Evaluation of the report of Tokyo Electric Power Company regarding the leakage from the RO concentrated water storage tank at the Fukushima Daiichi Nuclear Power Station

31 March 2015
Nuclear Regulation Authority, Japan

Evaluation of the report of Tokyo Electric Power Company regarding the leakage from the RO concentrated water storage tank at the Fukushima Daiichi Nuclear Power Station

10 December 2014
Nuclear Regulation Authority, Japan

Figure 2 Sampling points of seawater^{*2}
(As of October 2013)

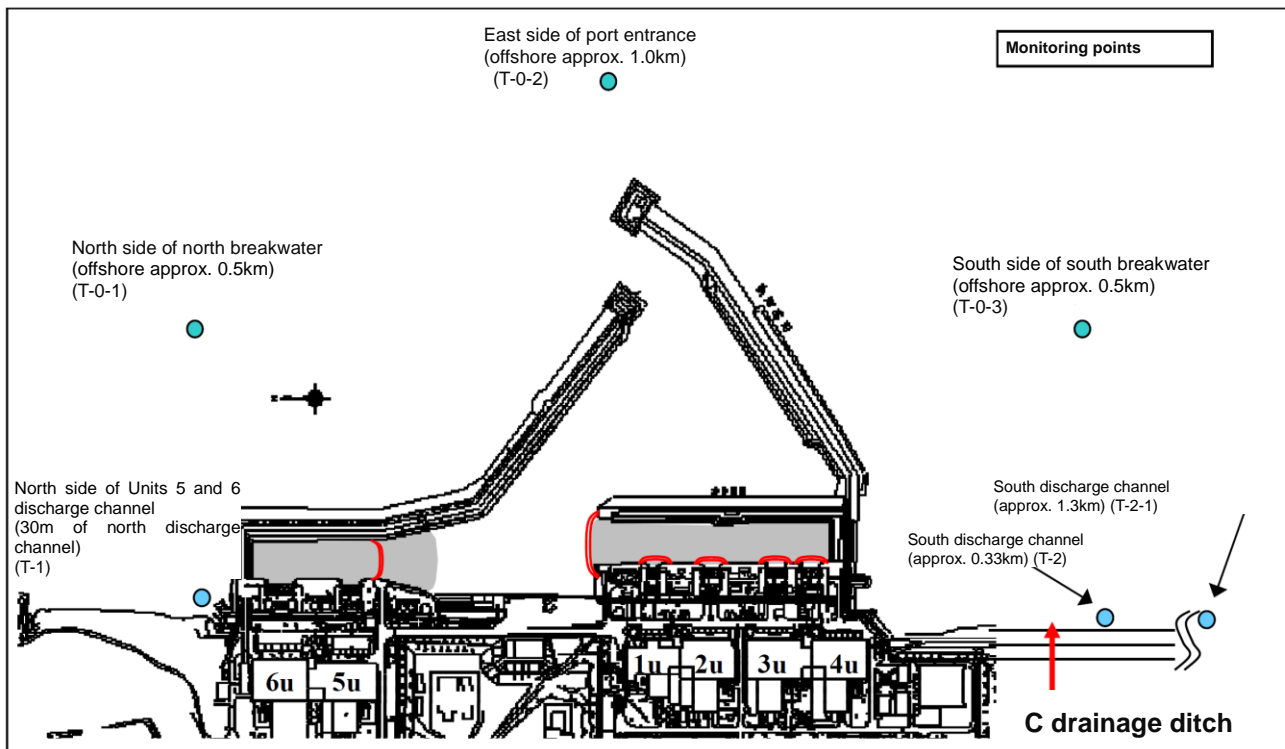
In terms of an environmental impact, no obvious increase in measurement results of total beta was detected in the seawater monitoring (refer to Figure 2) at the north/south discharging outlets (refer to Figure 3).

There is no obvious fluctuation in the monitoring results at the vicinity of the south discharging outlet (T-2-1) before and after the leakage of the tank. There is no detection of total beta that suggests leakage of the contaminated water leaked from the tank (total beta/radioactive cesium concentration rate is 10^3 to 10^4 (refer to Table 3)) to the ocean at the point T-2 which is the closest to the C drainage ditch after finding leakage.

Figure 6 External exposure dose values of beta ray on the workers who patrolled the tanks^{*2}

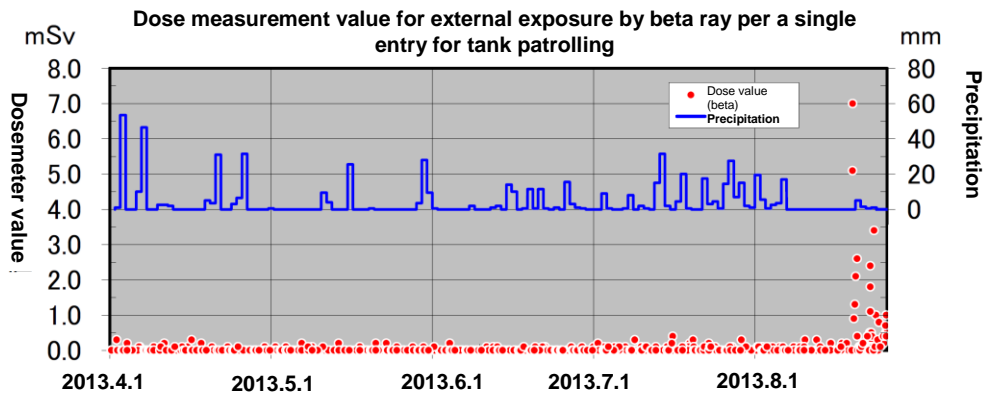
Figure 6 shows an external exposure radiation dose rate of beta ray on the workers who patrolled the tank around H4 north area.

Equivalent radiation dose to skin caused by effective exposure of radiation dose of the gamma ray and the beta ray to the workers who conducted patrol was evaluated in consideration of higher concentration of the beta ray radiation nuclide in the contaminated water leaked from the tank that is as high as the total beta/cesium concentration rate of 10^3 to 10^4 (refer to Table 2).

Figure 7 Location of leakage*2

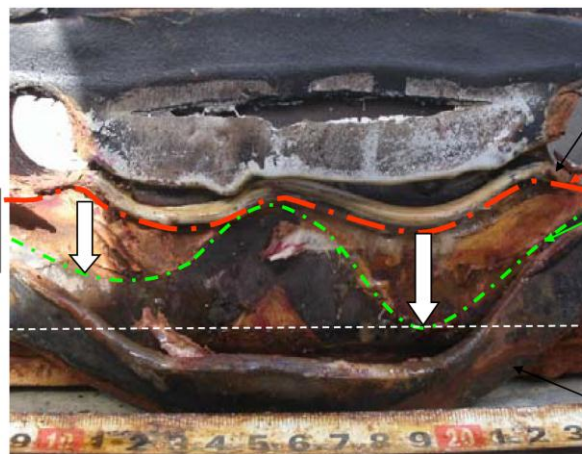
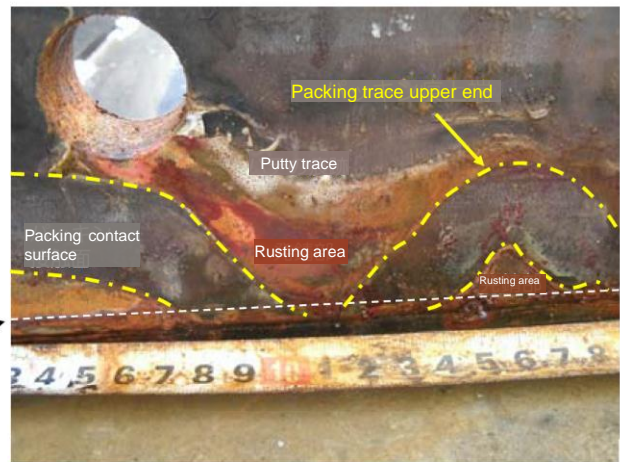
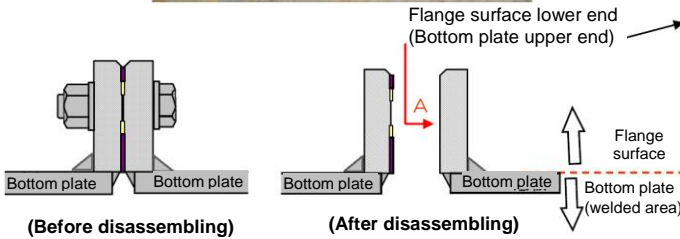
As a result, it was found that the leakage point was located at the discovered protrusion

of packing at the flange section of the tank bottom plate (refer to Figure 7). The assumed cause was estimated to be a reduction of bolt torque to tighten the packing, due to the impact of thermal expansion/shrinking of the flange caused by a subtle waving of the packing at the time of tightening the bolt at the location of the leakage. In addition, it was accompanied with the opening of the lower end of the flange. It is presumed that this led to the protrusion of the packing which shifted downward out of the bottom of the tank due to the inability to resist the water pressure of the tank.

Figure 8 Tentative countermeasures until replacing with welded tanks^{*2}

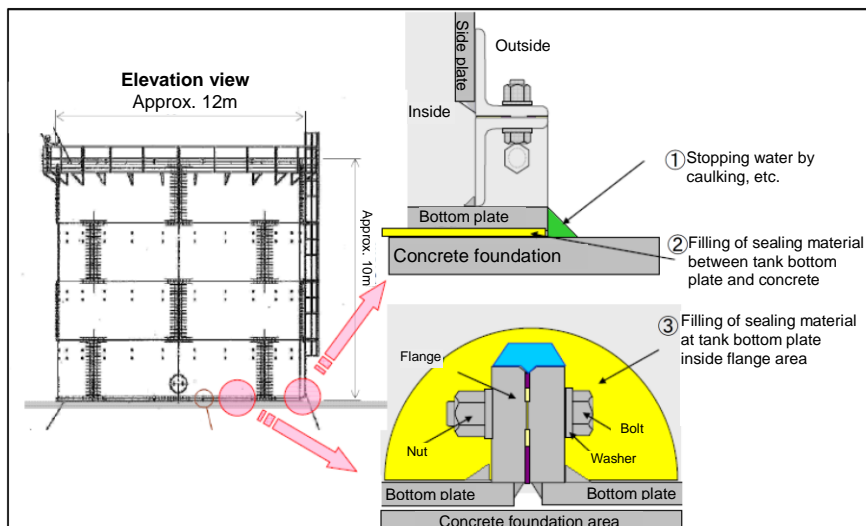
As tentative countermeasures until replacing with welded tanks, the implementation of following measures shall be considered (refer to Figure 8): 1) Waterproofing by caulking, etc. at the bottom of the tank, 2) Filling sealing material underneath the bottom plate, and 3) Filling sealing material at the bottom plate section (inside).

Figure 19 Future utilization principle of flange type tanks
(Extracted from the Secretariat of the NRA's document for a meeting with TEPCO)

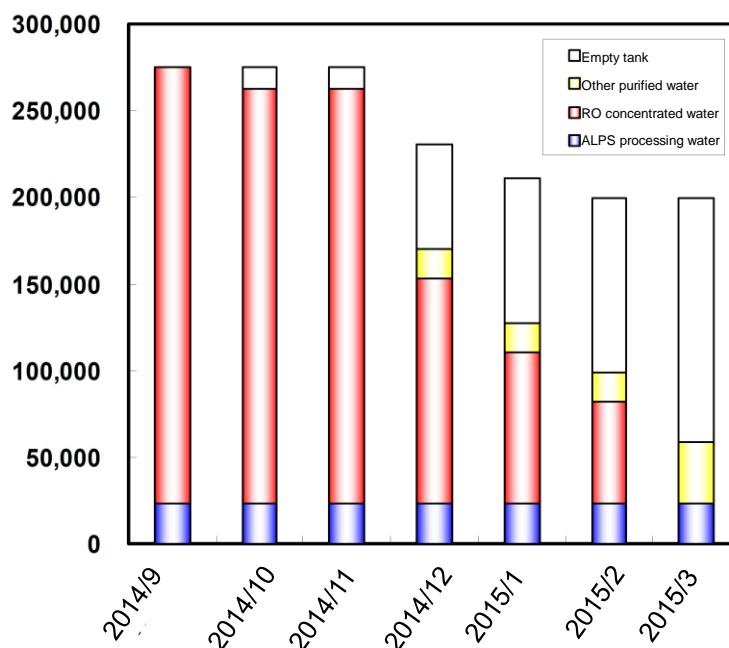
The Secretariat of the NRA has checked on the purification work and draining water by the purification system that are not described in the report in addition to replacing the tanks to welded tanks and tentative countermeasures in the Secretariat of the NRA's document for a meeting with TEPCO. It can be evaluated to have a certain level of effect for reducing risk of leakage since more than two countermeasures are implemented for both areas of tanks (refer to Table 4). Countermeasures summarized by TEPCO such as the replace measure of the flange type tank shall be checked about its implementation situation at an appropriate timing by safety inspection, etc. (refer to Figure 19).
